EC70139 REV. 0
ATTACHMENT Z111R0
DWG. NO. 522-041-021

NO.		DESCRIPTION		DRAWN
REVISIONS				
		NUCLEAR ENGINEERING		
		CRYSTAL RIVER UNIT 3		
		AUXILIARY BUILDING - SOUTH STEEL FRAMING MODIFICATIONS DETAILS		
		EWN DRAWN	JGC CHKD.	X APRVD.
C DISCP.	021 SHEET	DWG.	522-041	REV.

DETAIL A
SCALE: 1 1/2" = 1'-0"
DWG. S-522-004

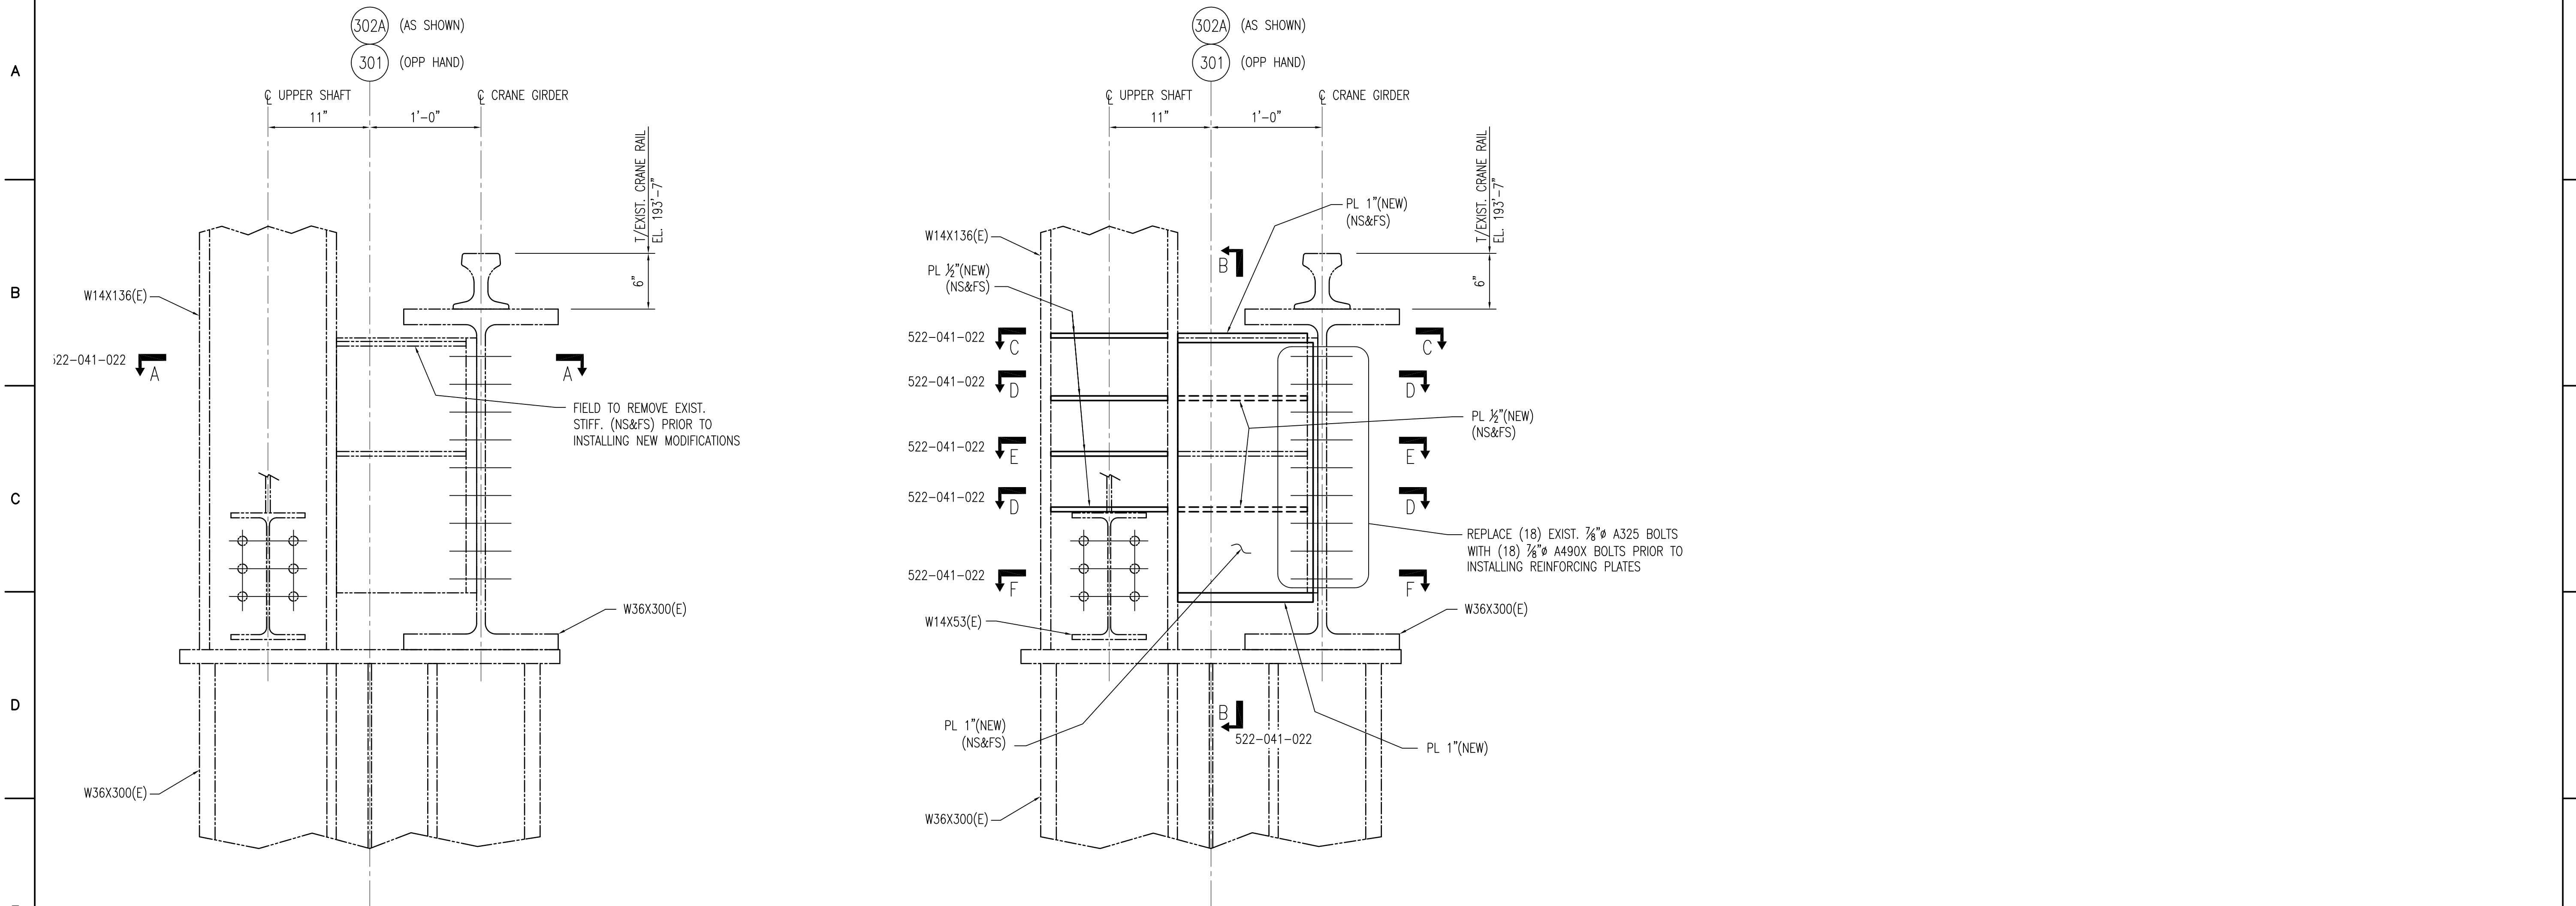
PHASE 1
FIELD TO REMOVE EXIST. MAT'L AS SHOWN & NOTED

PHASE 2
FIELD TO INSTALL NEW MAT'L AS SHOWN & NOTED
